**JOINT REGIONAL PLANNING PANEL  
(Northern Region)**

<b>JRPP No</b>	<b>2012NTH020</b>
<b>DA Number</b>	<b>DA12/0364</b>
<b>Local Government Area</b>	<b>Tweed Shire</b>
<b>Proposed Development</b>	<b>Construction of tourist accommodation development comprising of 355 tourist units, ancillary communal recreational facilities, on-site carparking for 375 vehicles and associated bulk earthworks, with access from the western extension of Kirkwood Road connecting to Fraser Drive.</b>
<b>Street Address</b>	<b>Firetail Street, Tweed Heads South</b>
<b>Applicant/Owner</b>	<b>Proportional Property Investment Ltd Atf PPI Wholesale Property Trust No 1</b>
<b>Number of Submissions</b>	<b>Three</b>
<b>Recommendation</b>	<b>Refusal</b>
<b>Report by</b>	<b>Colleen Forbes, Coordinator Development Assessment</b>
<b>Report date</b>	<b>6 May 2014</b>

## **Assessment Report and Recommendation**

**FILE NO: DA12/0364**

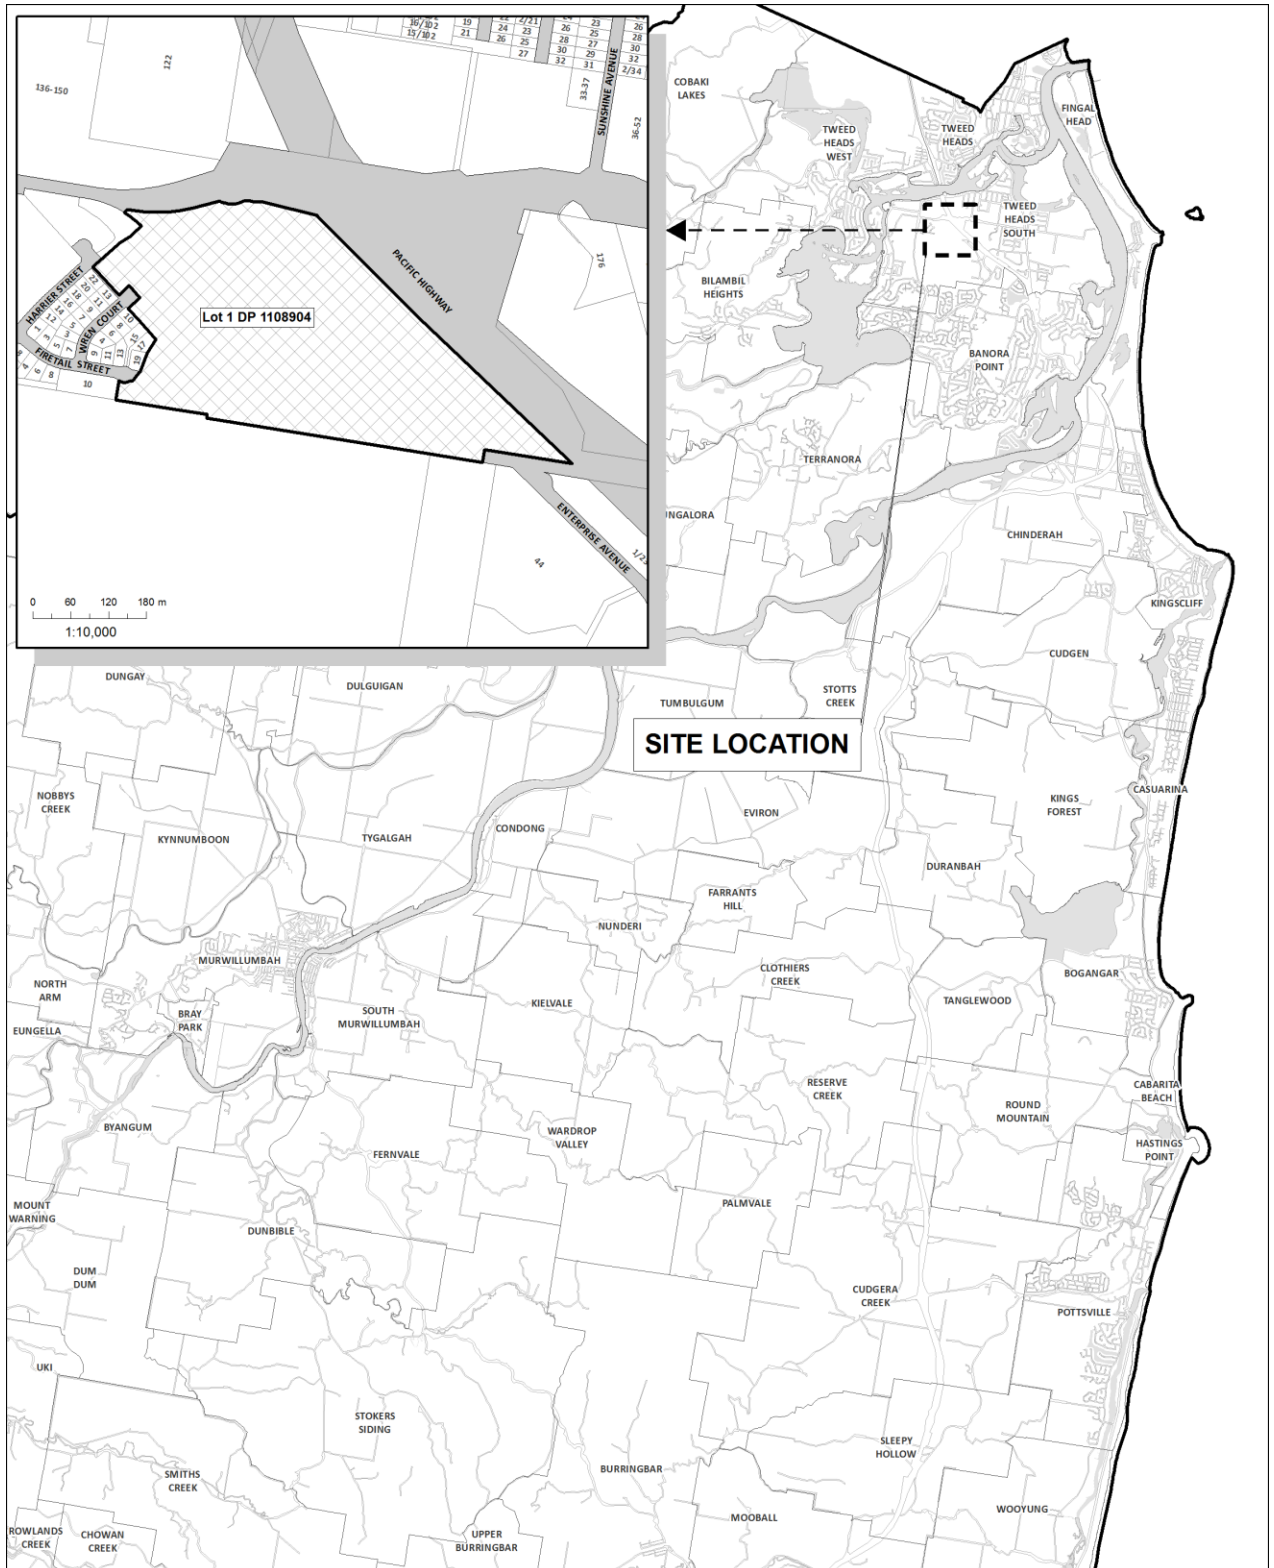
- **Design amendment to Communal Facilities Building** – a minor amendment has been made to the Floor Plan of the Communal Facilities building in relation to an internal reconfiguration of the reception, administration area and kitchen

area. External changes to the western side of the building include addition of a freezer, coolroom and delivery bay;

- **Waste Storage Areas** – arrangements for waste storage and collection have been refined. The Site Plan has been amended to include six bin enclosures around the site. The enclosures will be roofed and incorporate masonry block walls and sliding louvered panel gates;
- **Service Vehicle Area** – the plans have been amended to provide a service / delivery bay, to cater for a heavy rigid vehicle (HRV); and
- **Amended Stormwater Management Basins** – amendments have been made to the detail of the proposed stormwater detention basins “A” and “B”, in relation to the configuration of the basins and the measures to control discharge water.

**Figure 6 – LEP 2014 Zoning Map**

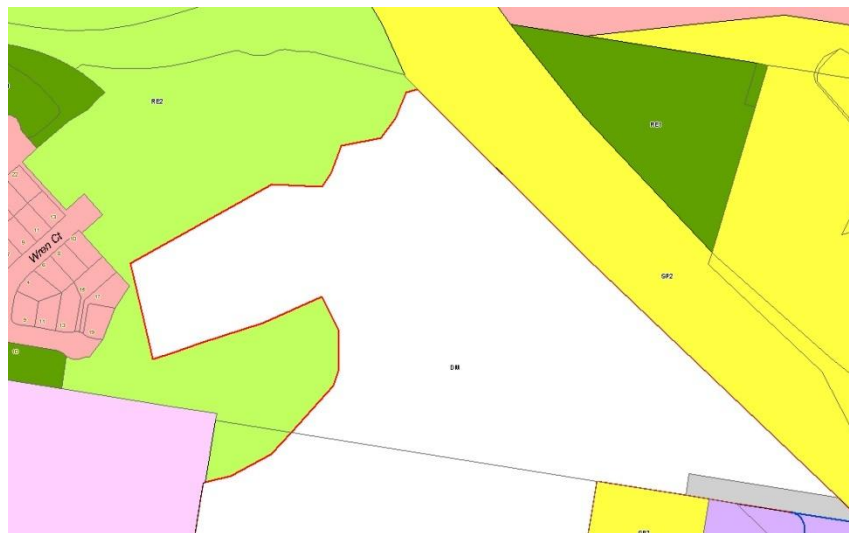
The subject site is part zoned as RE2 – Private Recreation under the provisions of this plan. The remainder of the site (shown in white in Figure 6 below) was proposed as an Environmental zone and as such is a Deferred Matter under the new LEP 2014. Until such time that NSW Planning & Infrastructure have finalised their review of Environmental zones on the North Coast, the deferred matter reverts back to the Tweed LEP 2000 zone.
